CR238 – Oil Cooler Hose Spacer Installation

Hypermotard 939 STD/SP MY16-18 (all versions)
Hyperstrada 939 MY16-17 (all versions)
Safety Recall Campaign SRV-RCL-22-002

Date: September 27, 2022
To: Dealer Principal, General Manager, Service Manager, North American Dealer Network
From: Richard Kenton, Technical Director
Dan Schwartz, Service Area Manager

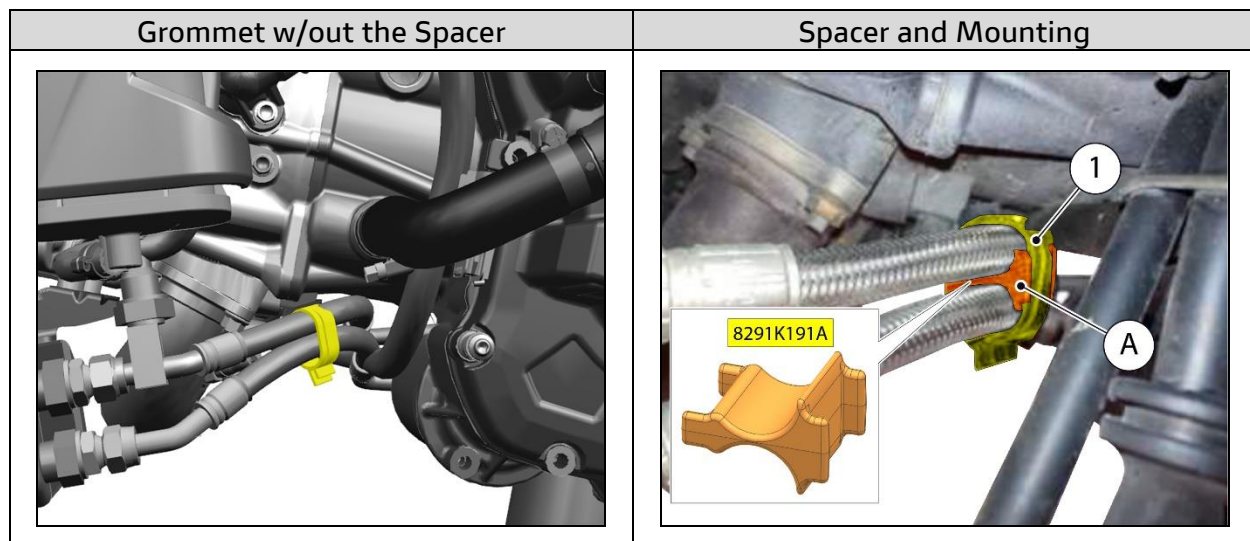
This bulletin has been produced due to a potential problem associated with the rubbing of the oil cooler delivery and return hoses, which could lead to damage and oil leakage from the hoses. A new component, **spacer (A) (Part no. 8291K191A)**, has been made to be placed between the hoses and inside the **hose grommet (1)**, to prevent the contact described above.

The **spacer (A) (Part no. 8291K191A)** must be installed only on motorcycles equipped with **hose grommet (1)**.

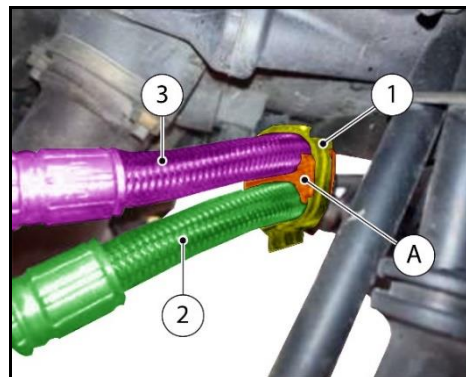
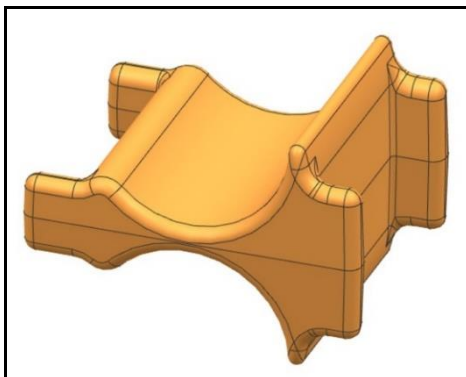
1. Position the motorcycle on a rear paddock stand
2. FOR HYPERSTRADA ONLY: Remove the sump guard
3. Release **hose grommet (1)** and move **oil return lower hose (2)** away from **oil delivery upper hose (3)**

4. Take spacer (A) Part no. 8291K191A and insert it inside **hose grommet (1)**; then re-hook **hose grommet (1)** to the closed position

To correctly hook **hose grommet (1)**, exert a slight pressure on its closure.
